Subdivision #2026-00001
411 Clifford Avenue

Application	General Data	
Request: Public hearing and consideration of a request for a Subdivision to re-subdivide an existing lot into two lots with a variation to floor area ratio.	Planning Commission Hearing:	May 5, 2026
	Approved Plat must be Recorded By:	November 5, 2027
Address: 411 Clifford Avenue	Zone:	R-2-5/Residential
Applicant: Teresa Elaine Lustig, represented by Duncan Blair, attorney	Small Area Plan:	Potomac West
Staff Recommendation: APPROVAL subject to compliance with all applicable codes, ordinances, and recommended conditions found in Section IV of this report.		
Staff Reviewer: Catie McDonald, catherine.mcdonald@alexandriava.gov Sam Shelby, sam.shelby@alexandriava.gov

Figure 5 – Proposed Lots (501 in red, 502 in blue)

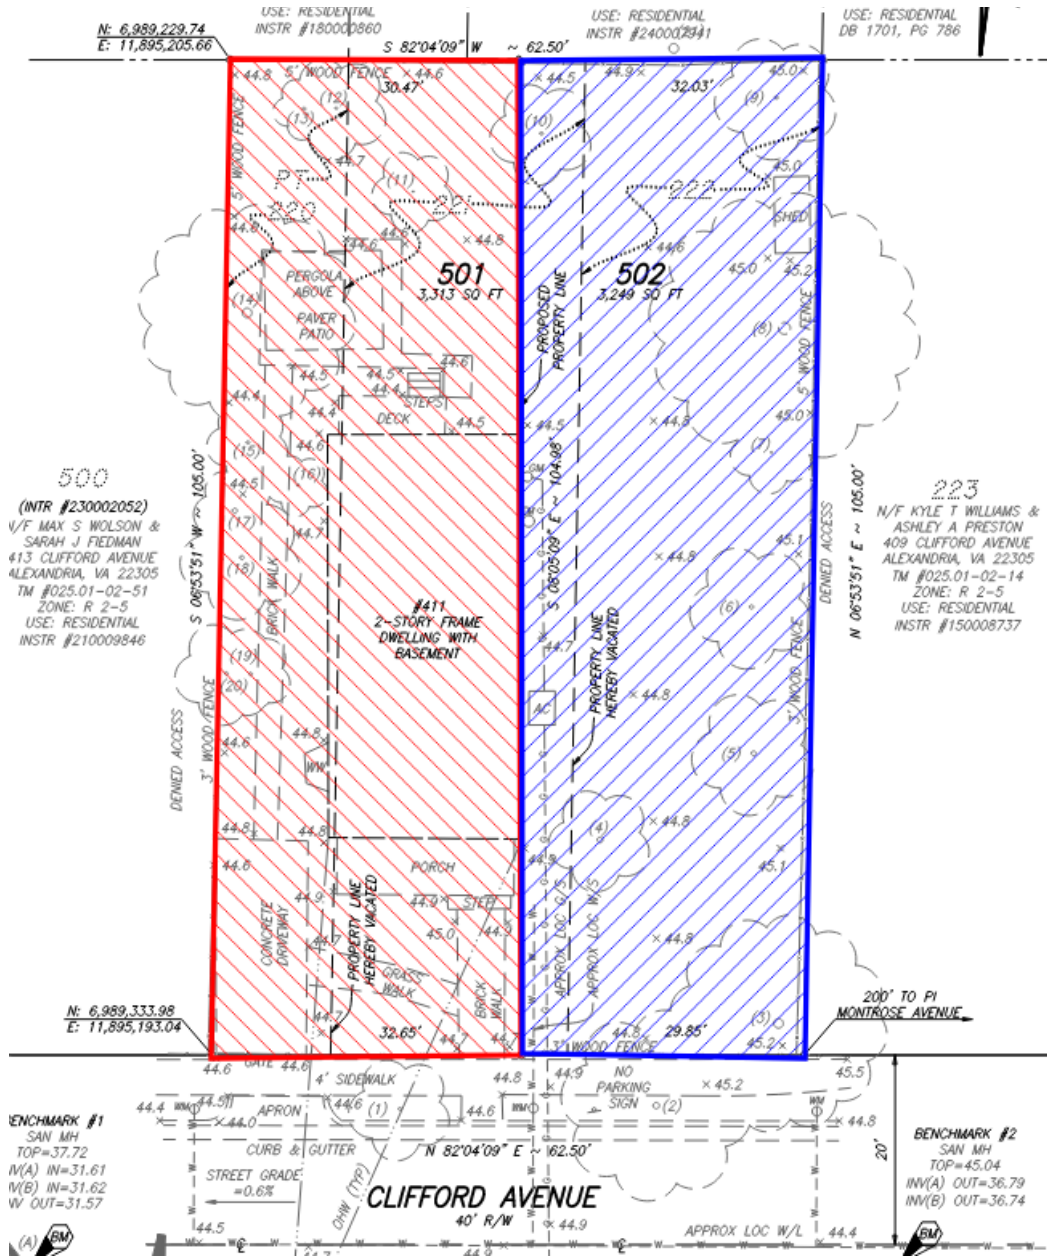
- F-1 As the grading plans develop, explore ways to minimize impacts to existing on-street parking by repeating the “character” (i.e., width) of existing driveway on the newly proposed lot. This would effectively preserve at least one on-street space in front of the site. (Transportation Planning)

- C-1 Exterior walls located less than 5 feet from the lot line shall be of 1-hour fire-resistance-rated construction in accordance with Virginia Residential Code Section R302.1(1). The proposed new lot line shall not be located within 5 feet of the existing building's exterior wall unless the wall is upgraded to meet the required fire-resistance rating.

- C-2 Openings are not permitted in exterior walls where the fire separation distance is less than 3 feet from the lot line. In addition, for unsprinklered buildings, the total area of openings in a wall with a fire separation distance of 3 feet or more but less than 5 feet shall not exceed 25 percent of the wall area. Therefore, if a new lot line is established within 5 feet of an exterior wall, all openings in the existing exterior wall facing the lot line shall be verified for compliance with Virginia Residential Code Table R302.1(1).

- C-3 Projections shall not be located closer than 5 feet to the lot line. In unsprinklered buildings, projections with a fire separation distance of less than 5 feet shall be protected on the underside. Therefore, no new subdivided lot line shall be

established within 5 feet of any existing projection unless the projection complies with these protection requirements.
